## PLANNING COMMISSION RECOMMENDATION

SDP-8597-2020

**SUBJECT:** Final Staff Analysis  
Application SDP-8597-2020: 700 North Frederick Avenue

Exhibit #89

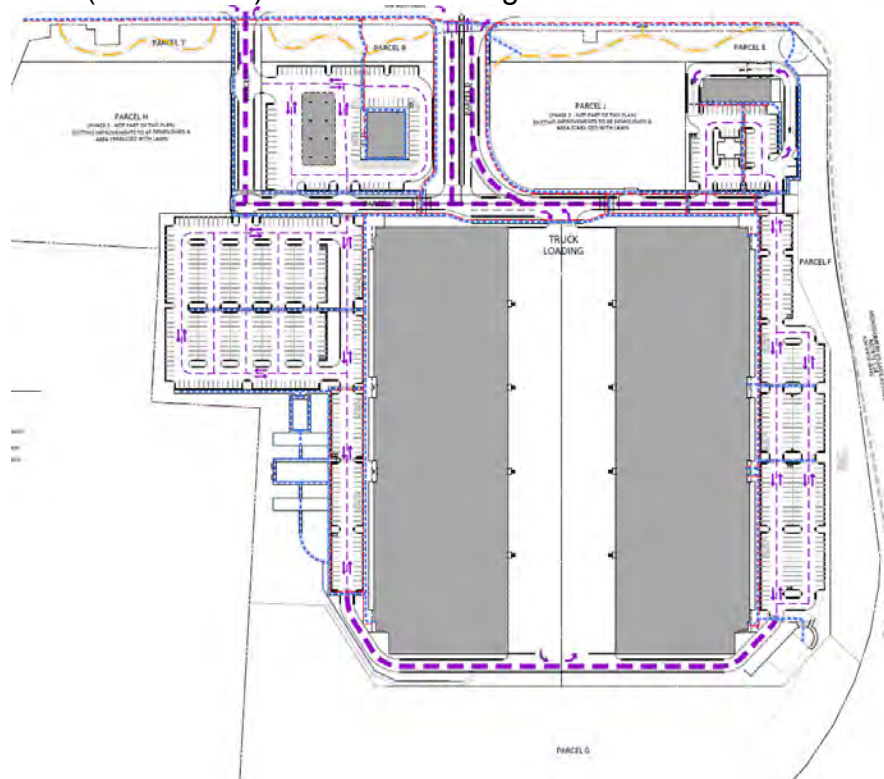
### Staff Comments

Staff is supportive of the circulation plan and is pleased that the redevelopment of this property provides multiple new pedestrian and other non-vehicular access points to and through this previously access-restricted site. The applicant has provided sufficient information to provide staff with confidence that the vehicular movements of multiple types of large vehicles can be accommodated safely on site. Additionally, staff is appreciative that the applicant has designed its roads in accordance with the City's current road code standards.

Exhibit #56

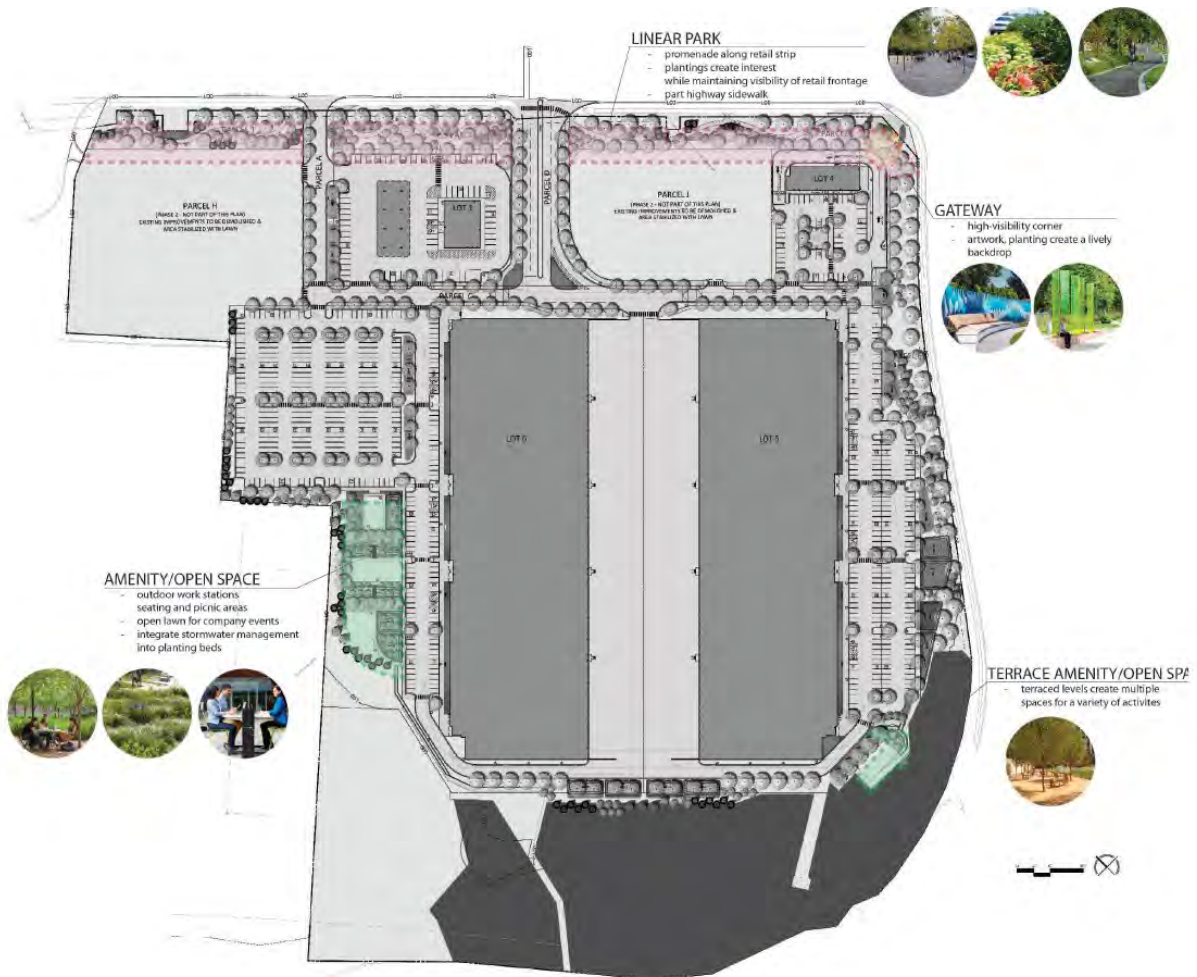
### Staff Comments

Staff is supportive of the applicant's plans for the expansion of the naturalized area on site, the creation of a new conservation easement, the addition of several hundred trees on site, and the integration of stormwater facilities in the employee amenity areas. The plans will help to improve the environmental quality of the site as it redevelops. Staff is also pleased that the applicant plans to develop the entire North Frederick Avenue linear park in this phase of development, providing a long-planned amenity to the northern employment district. As

noted previously, the applicant's plan for this extension of the linear park is reduced from a depth of 100 feet (along the FedEx site just north of the subject site) to 70 feet. According to the applicant (Exhibit #58), the reduction in depth is intentional to draw pedestrians into the space, provide multiple links to North Frederick Avenue, and offer opportunities for respite, shade, and beauty. Activation is expected to be promoted by adding visible seating locations designed with Crime Prevention through Environmental Design ("CPTED") principles in mind through several connections to the existing shared-use path. The applicant has emphasized that siting new commercial structures closer to the roadway enhances visibility for new businesses, promotes a more urban form, and supports the economic viability of redevelopment. Staff remains wishful that the linear park could be further widened to meet the width of the existing portion of the park.

Exhibit #5

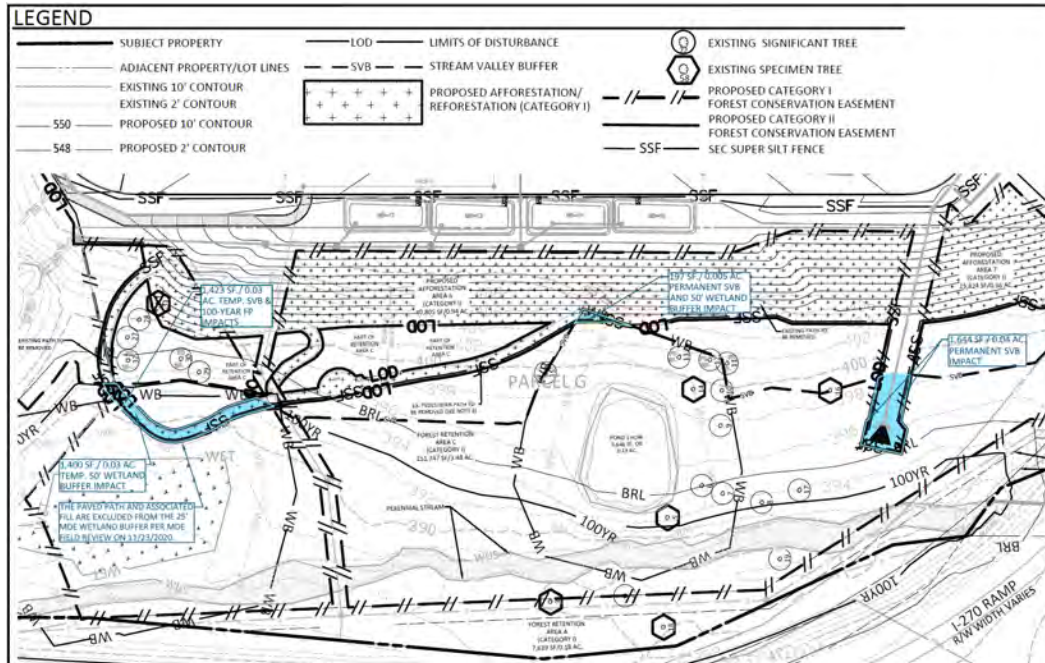
### **Staff Comments**

The Applicant has submitted a supplemental request and justification statement for the environmental waivers (Exhibit #72b and #74). Upon review, staff concurs and notes there to be adequate mitigation of the temporary and permanent impacts. Staff further notes an overall improvement of the environmental buffers surrounding sensitive areas on the site. These improvements are achieved both through the removal of impervious surfaces and the planting and naturalization of existing lawn panels with trees. Given this enhanced canopy context, staff supports these waivers request.
